**AGENDA
TOWN OF PITTSFORD
PLANNING BOARD
AUGUST 11, 2025**

Passero Associates, Pittsford Oaks Apartments
Final Site Plan

**Re: Pittsford Oaks Apartments | Final Site Plan Submission
Comments dated July 25, 2025**

LANDSCAPE
PLAN

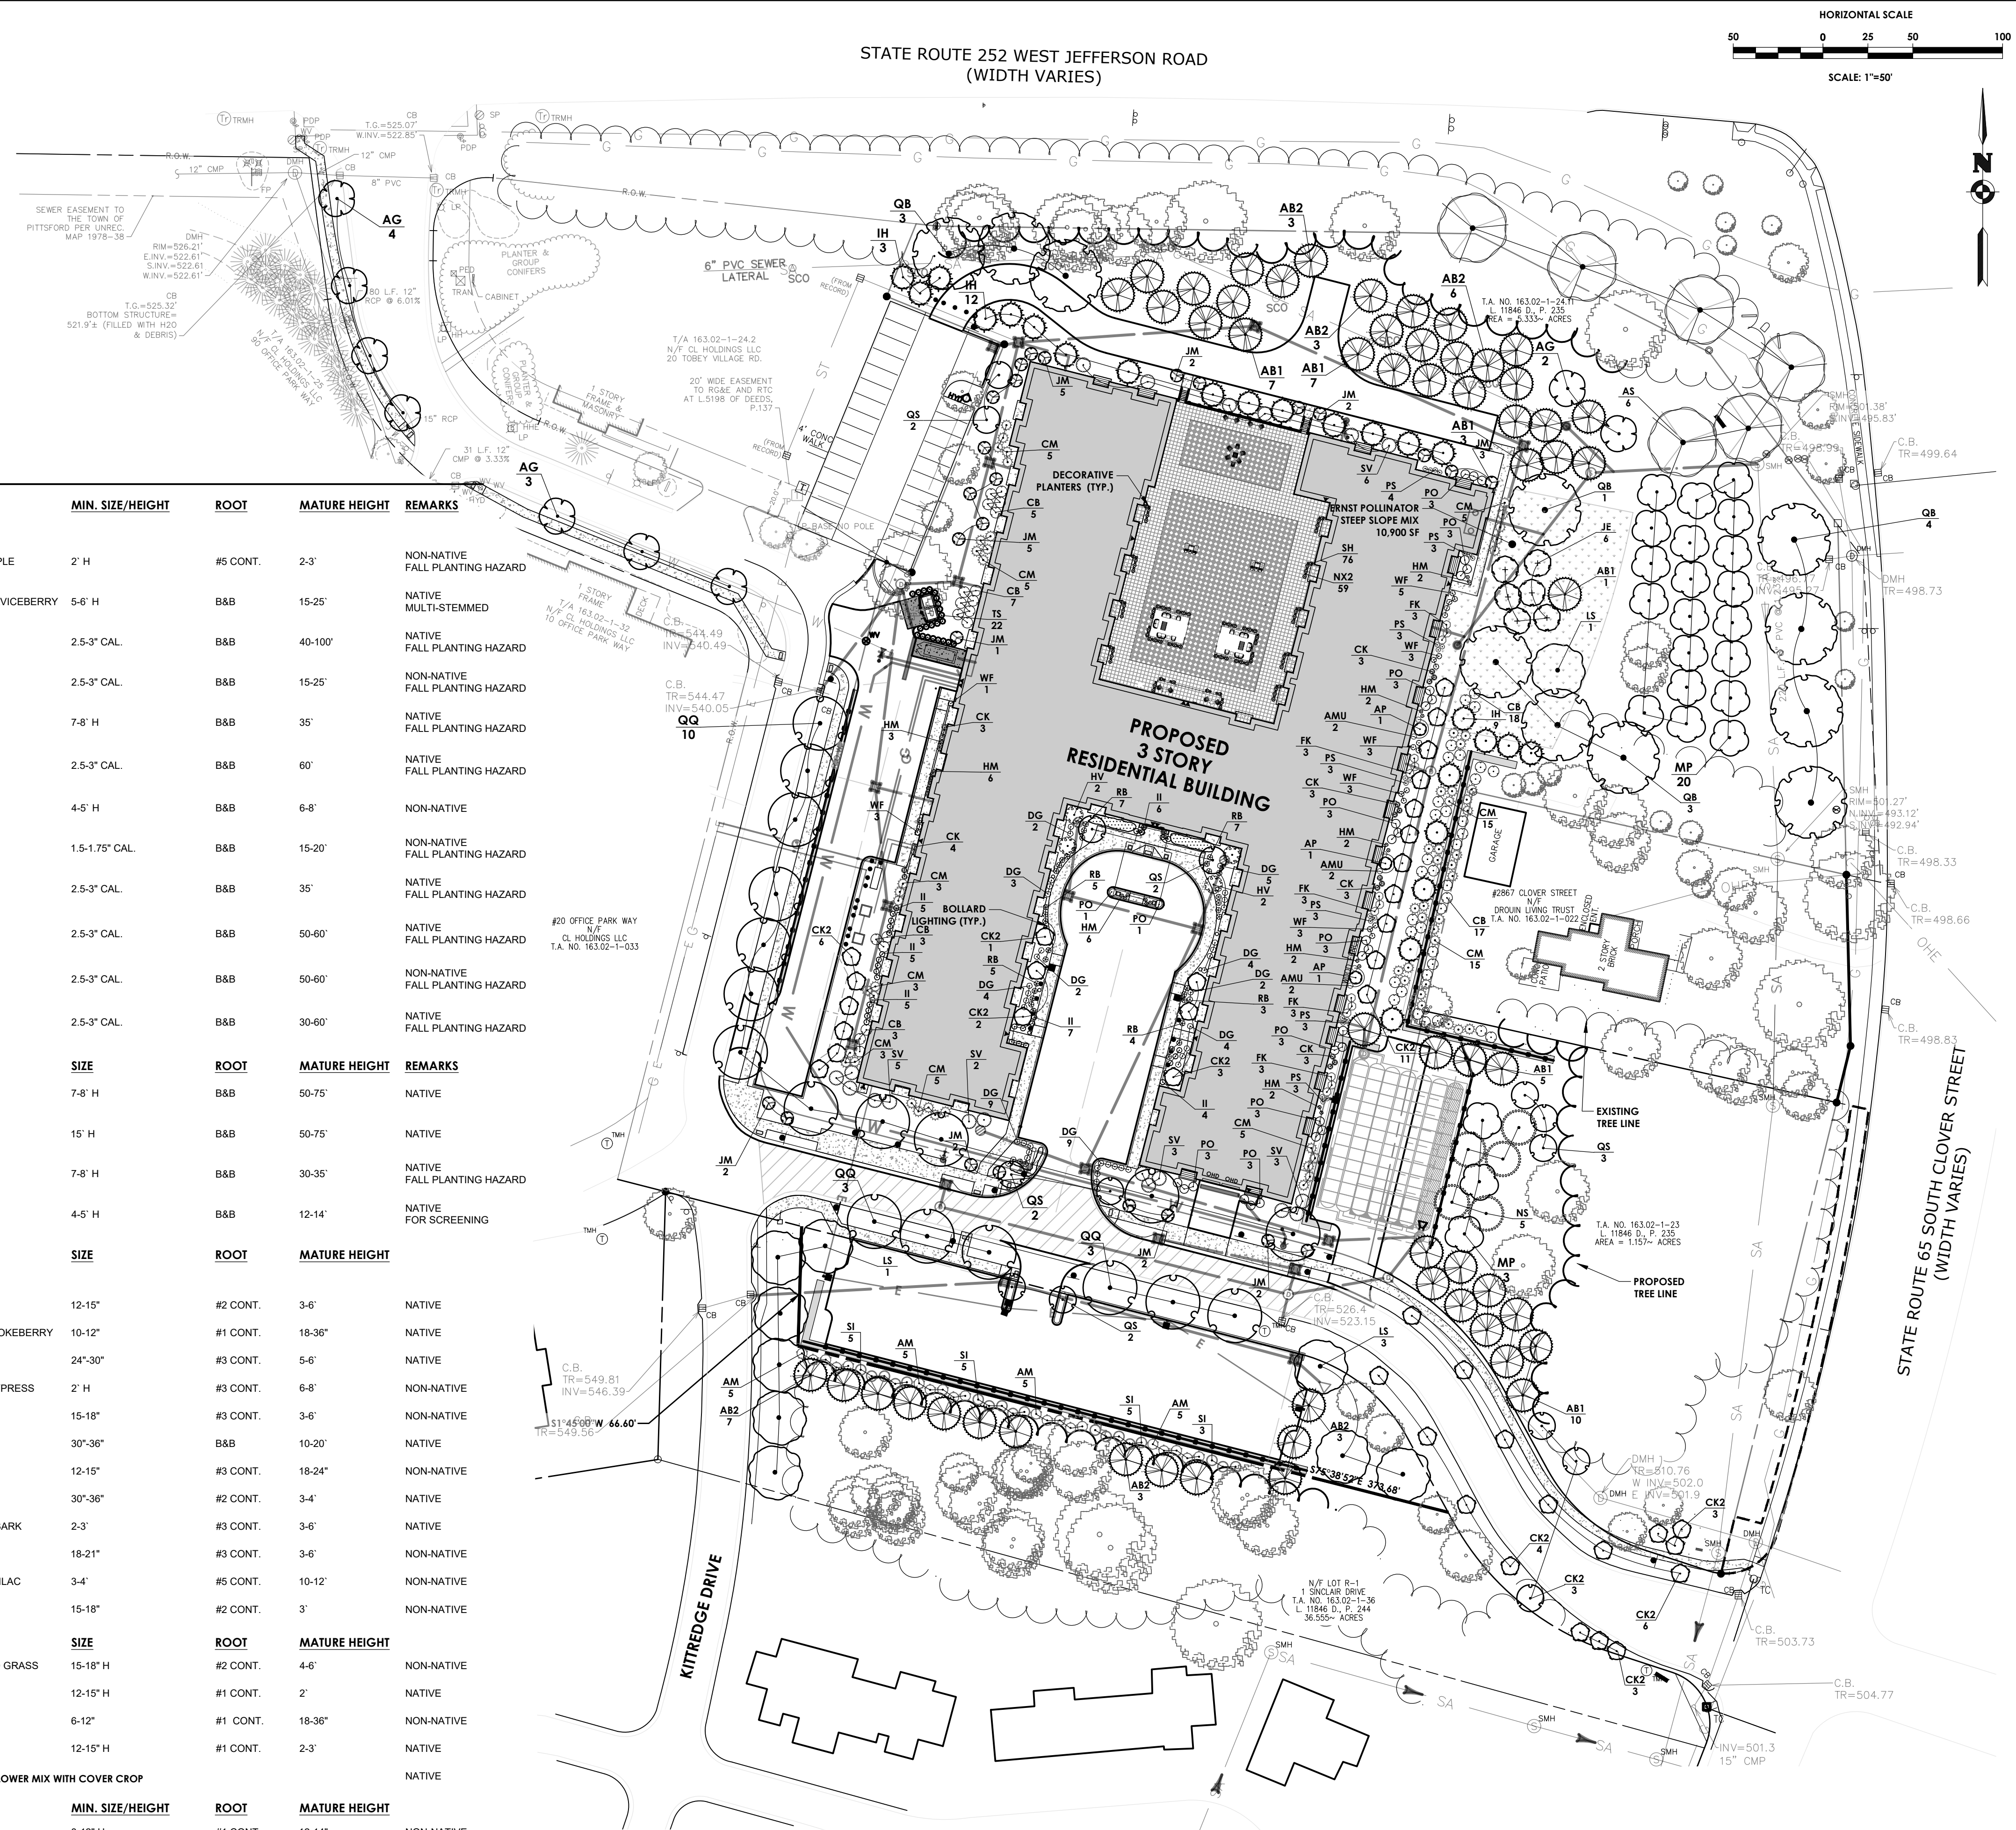
25. Please add a note to the plans stating, "Plantings within the Tobey Village Road right-of-way will not be maintained or replaced by the Town of Pittsford and will be conducted by the property owner."

28. Two oak trees to the east of the main entrance are missing labels.

40. Snow storage is now shown on the plans and is in areas with landscaping.

Response: Note included on Landscaping Plan as requested.

Response: Labels included on landscaping plan as requested.

Response: Snow storage shown on landscaping plan and out of landscaped areas as requested. Excess snow will be removed offsite during large snowfall events.
